D0901137 – BSC1-H1

MASSES

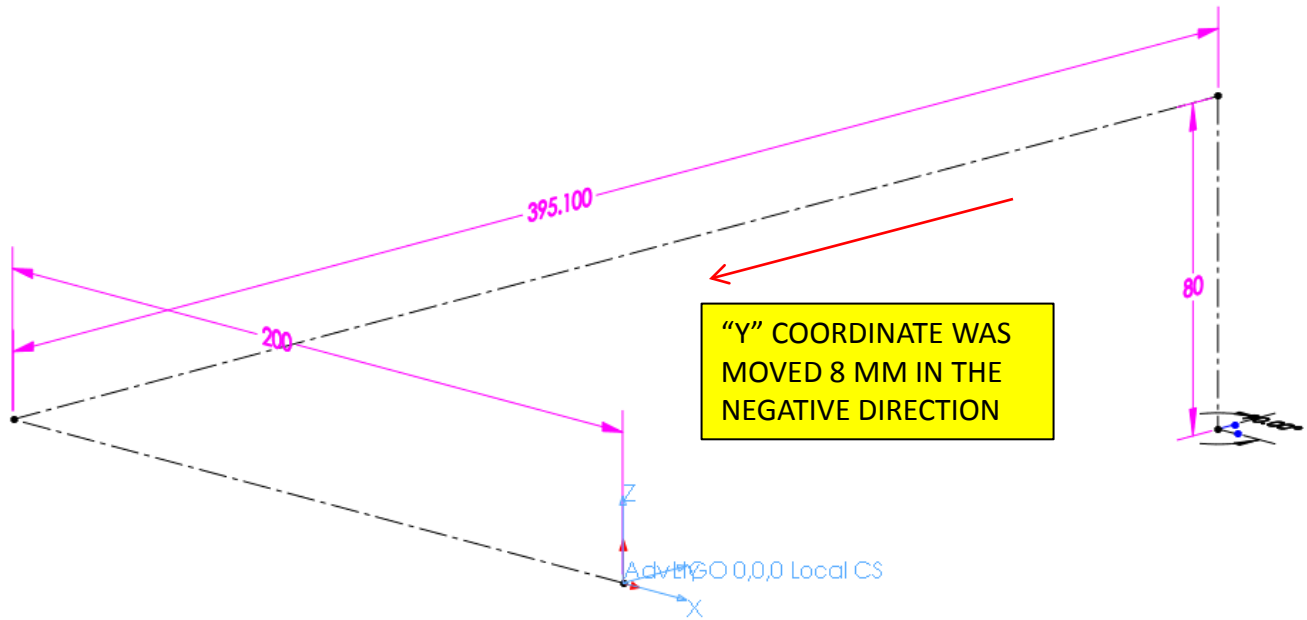
EXISTING COORDINATES:
X = -200.0 mm
Y = 403.1 mm
Z = -80.0 mm

“Y” COORDINATE WAS
MOVED 8 MM IN THE
NEGATIVE DIRECTION

PROPOSED COORDINATES:
X = -200.0 mm
Y = 395.1 mm
Z = -80.0 mm

PROPOSED DOG CLAMPS LAYOUT,
QUAD MOVED 8MM IN THE NEGATIVE
"Y" DIRECTION
(BOTTOM VIEW LOOKING UP)

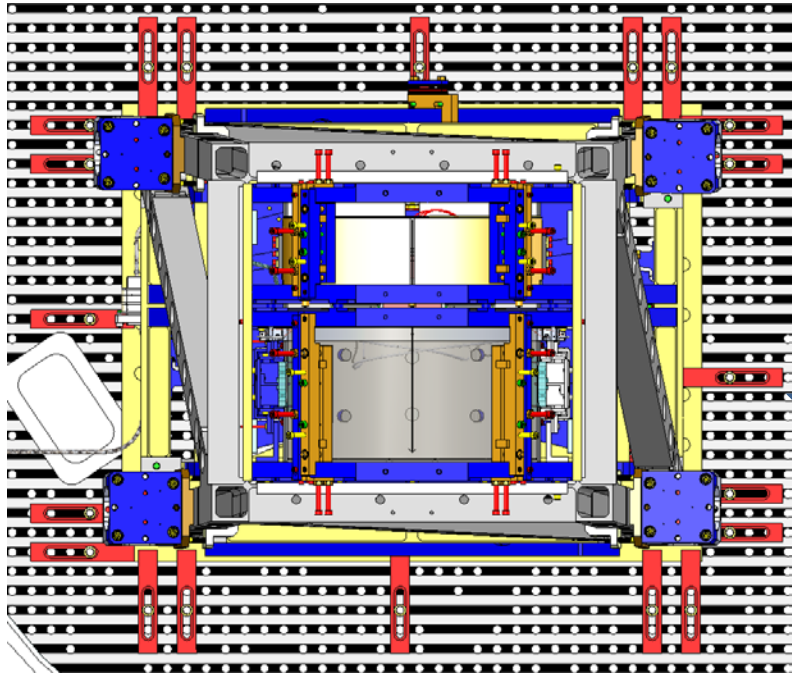
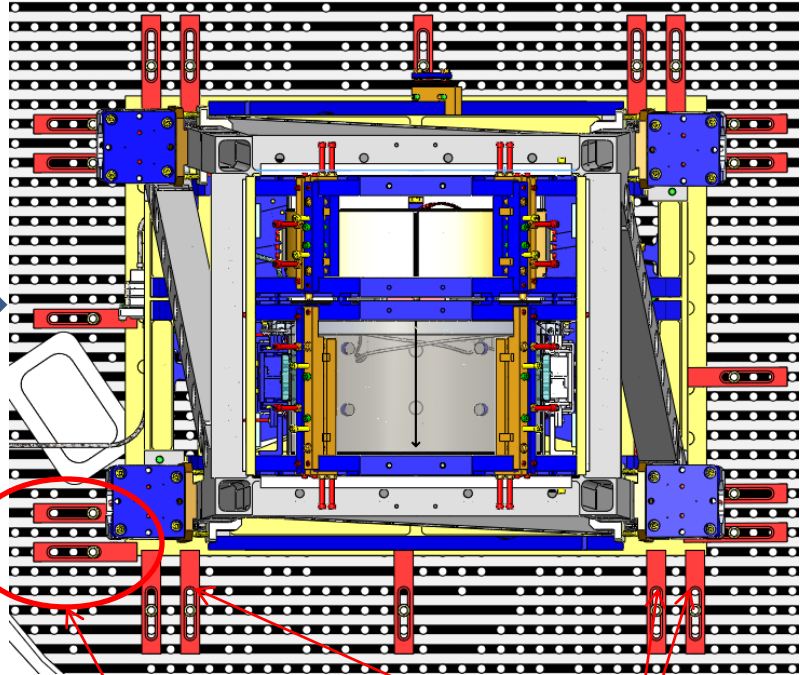
COMMENTS:
MOST OF THE DOG CLAMPS ARE NOT
AFFECTED BY THE MOVE, EXCEPT THE FIVE
YOU SEE IN THE RIGHT PICTURE

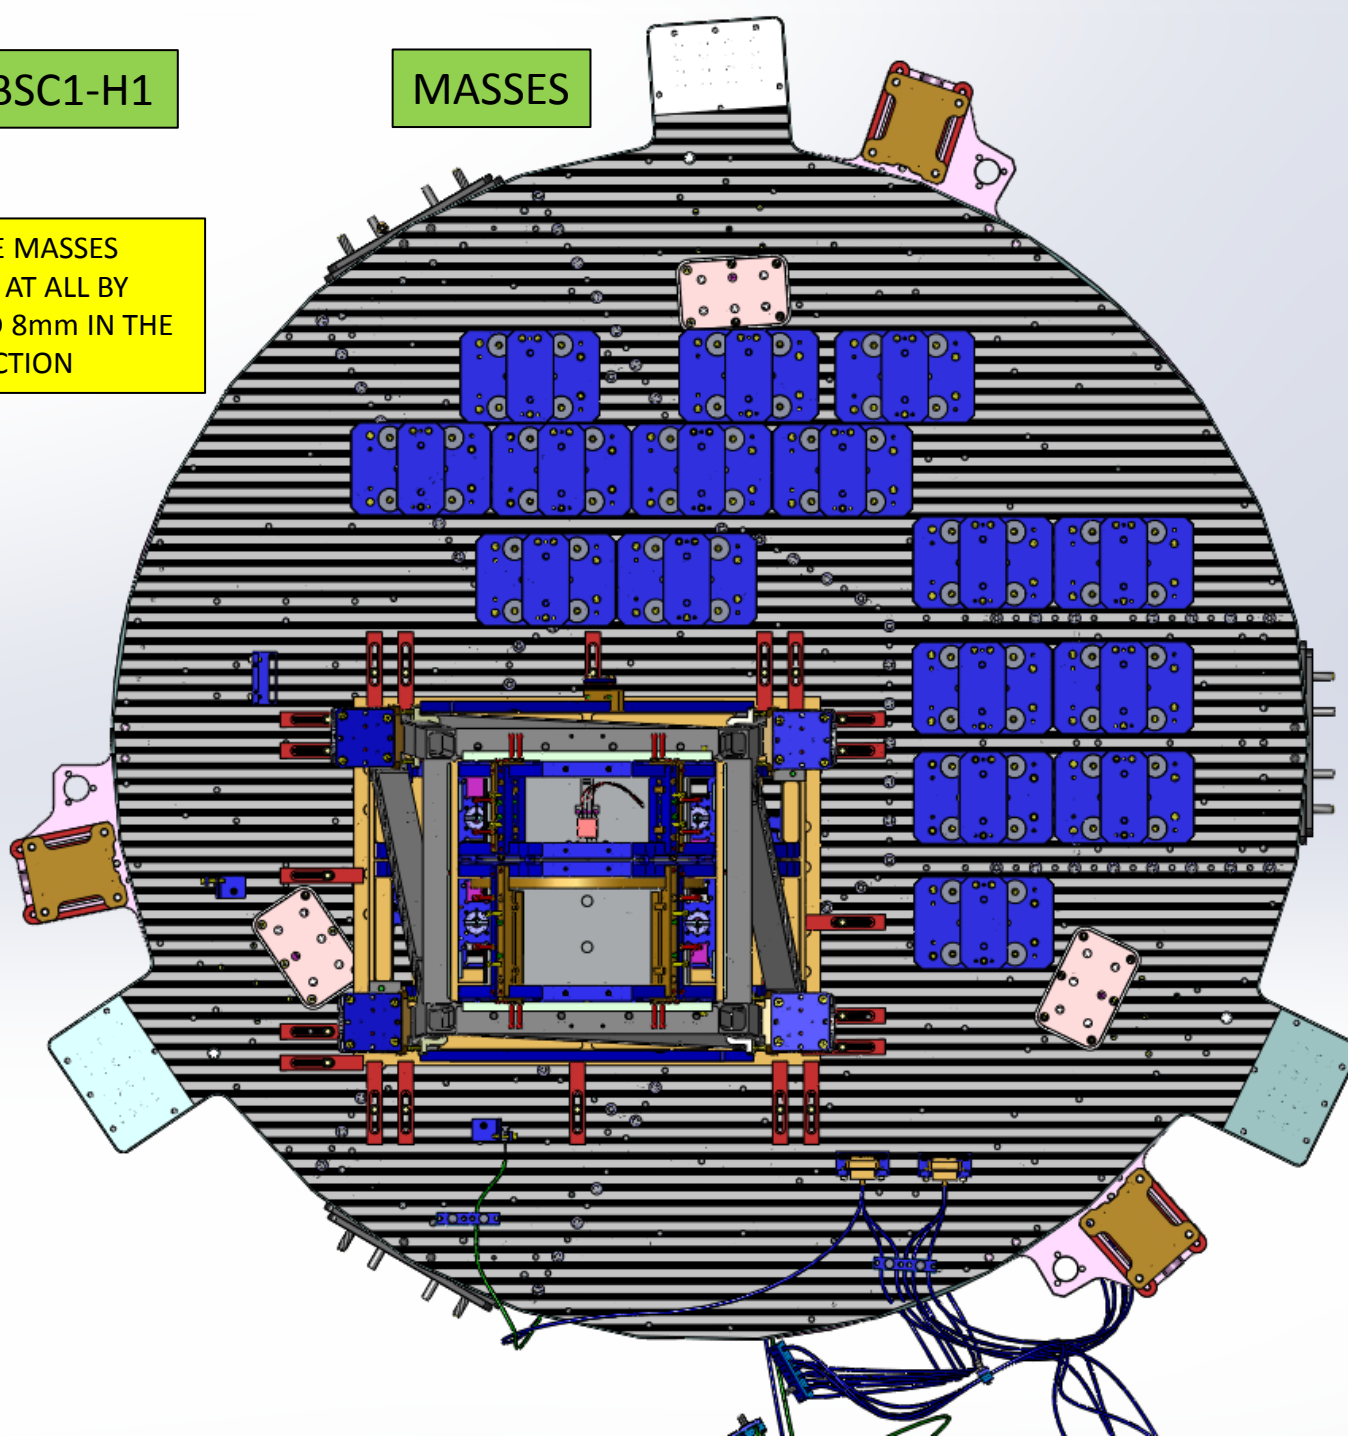
THESE TWO DOG CLAMPS
NEED TO BE MOVED ONE
HOLE IN THE NEGATIVE
DIRECTION

THESE 3 DOG CLAMPS NEED
TO HAVE ONLY THE SCREW
MOVED ONE HOLE IN THE
NEGATIVE DIRECTION

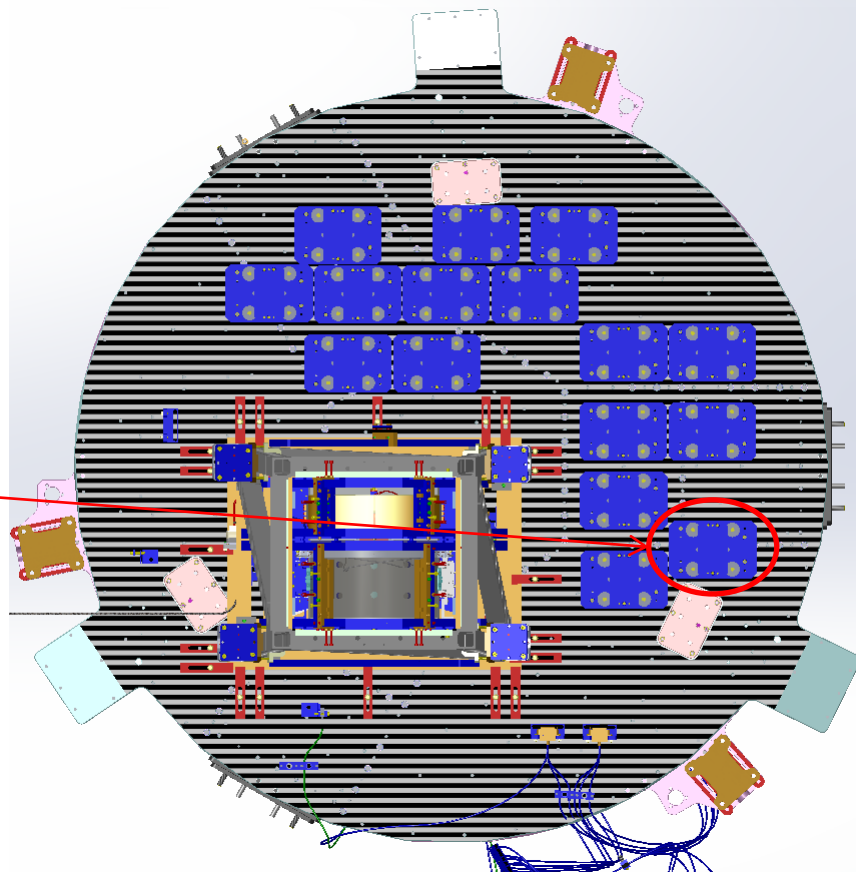
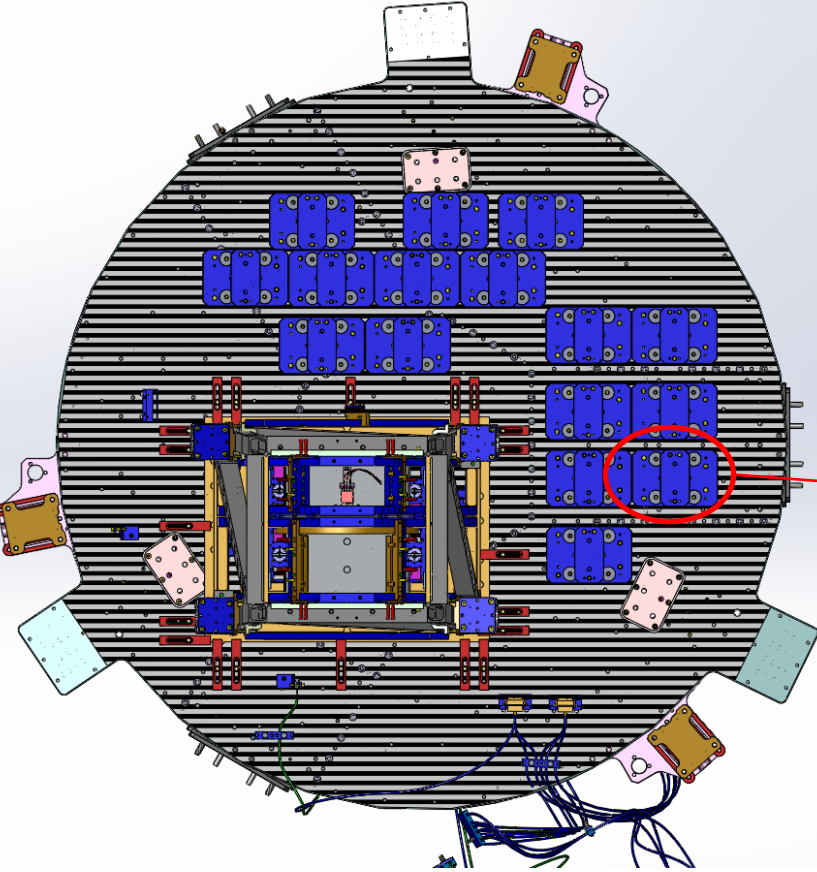
THE CG OF THE EXISTING POSITION
 OF THE QUAD IS GIVING BY :
 Z = 256.62 mm
 (FOR THE NON-SUS MASS CONFIG.)

THE CG OF THE PROPOSED POSITION
 OF THE QUAD IS GIVING BY :
 Z = 256.62 mm
 (FOR THE NON-SUS MASS CONFIG.)
